CALIFORNIA COASTAL COMMISSION

2-15-1357-A1 (San Francisco Public Utilities Commission Armoring, Ocean Beach)

CORRESPONDENCE

Re: Item W11a, Coastal Development Permit Amendment No, 2-15-1357-A1 – San Francisco Public Utilities Commission South Ocean Beach Permit Extension

Figure 4
Ocean Beach Master Plan Vision and
Low-Profile Protection of the LMT In-Place

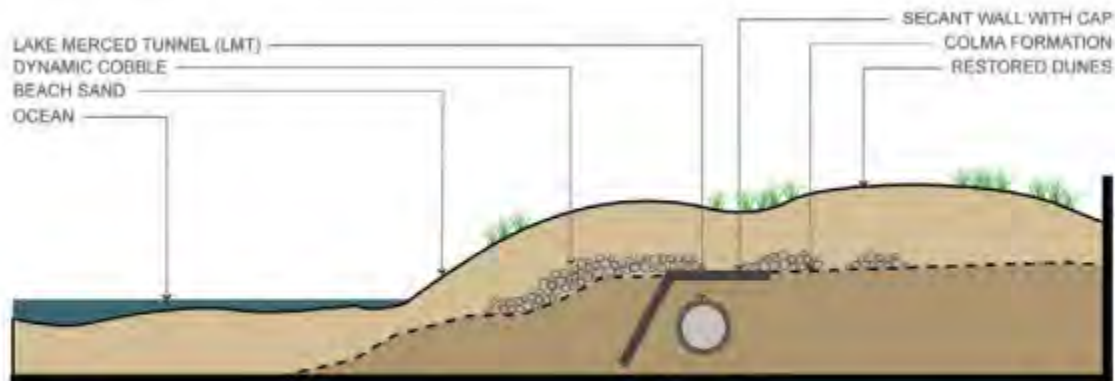
At the heart of the developing coastal adaptation project was a low-profile buried seawall to protect threatened wastewater infrastructure. The wall, under average beach conditions, would be buried under sand, allowing wave run-up and sand transport to occur on top of and behind the structure. Reliance on sand replenishment would be minimized. The concept is depicted in Figure 4, below.

During heavy storm events with coastal erosion, it was expected that the shoreline elevation would drop, exposing the seawall up to ten feet, fronted with cobblestone that would aid in blocking wave run-up while providing protection of SFPUC infrastructure and public access. As spring and summer sand accretion processes returned, the wall would become reburied. In 2015, City engineers and SFPUC signed off on the analysis of this design, which concluded that such a low-profile structure would be viable and meet project objectives. Surfrider was in support of this project design and expected this to be the final design concept.

Figure ES-5: Low Profile Wall-Representative Section

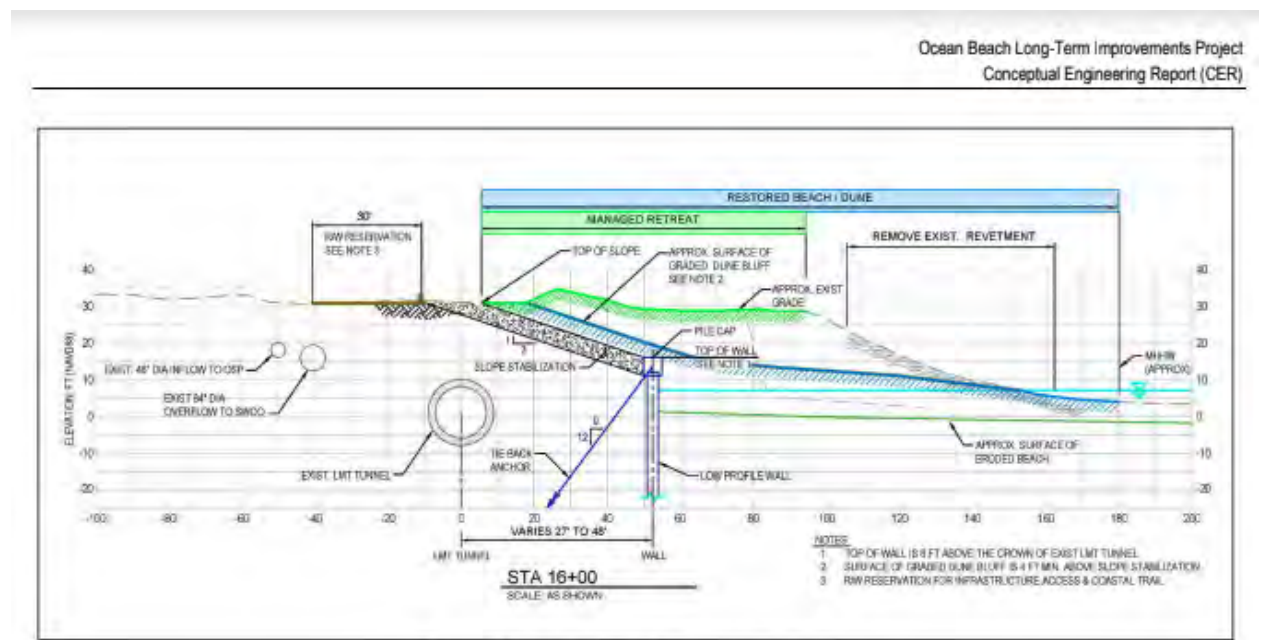
Instead, SFPUC commissioned a new conceptual design with Moffatt and Nichol, et.al., in 2019, *Conceptual Engineering Report: Ocean Beach Long-Term Improvements Project*. The City has already initiated the EIR process based on this new model and the “low profile wall” proposal we anticipated has been replaced with plans for an up to 45 foot wall, potentially twice the height of the vetted structure. The wall proposal is also now twice as wide (77 feet with a sloped shotcrete cap as opposed to the ESA 2015 conceptual model which was speculated at 36 feet wide with a flat cap). The new wall design would also sit 20 to 40 feet further seaward than originally proposed, where it is

likely increasing risk of exposure in this area of highly active wave energy. See figure ES-5 from Moffatt and Nichol in 2019, below.

This is not the adaptive project that was discussed in the OBMP process or the LCP Update, nor is it even a “least environmentally damaging alternative” that we have worked on collaboratively for at least the past five years. The new and much larger seawall plan, although initially covered with sand, would undoubtedly be much more prone to erosion. This means there could be a greater need for sand replenishment if it is to remain buried; and there is a higher probability that the structure will become a coastal access hazard when subjected to excavation due to erosion. With its wide sloped crown, the adaptive benefits of a living shoreline are also greatly diminished as sand retention and wave transport on top of and behind the structure are less viable. The new wall is clearly not in line with the OBMP vision.

The new design also suggests a soil stabilization layer composed of soil cement mixture to prevent scouring around the seawall. Surf rider has historically objected to similar cement mixtures. The staff report for application number 6-15-1988 regarding a seawall application in Solana Beach concedes that historically, erodible concrete has not eroded at the same rate as the bluffs. The Coastal Commission denied application 6-15-1988 because it would perpetuate a type of coastal armoring that has not been proven to erode as claimed by the applicant, and is instead likely to act as a ‘de facto’ seawall that erodes the beach.

- a. Request additional analysis and scrutiny of the width, height, and location of the currently proposed seawall compared to original 2015 design;
 - b. Request additional analysis and scrutiny of the need, function and erodibility of the proposed soil stabilization layer compared to cobble berm in the original 2015 design;

1. Redirect SFPUC to explore opportunities for reinstating the 2015 design.
2. If the 2015 design is not fully restored after these steps, SFPUC should be required to specify which aspects of the design are not viable and provide analysis. Specifically, the Commission should:
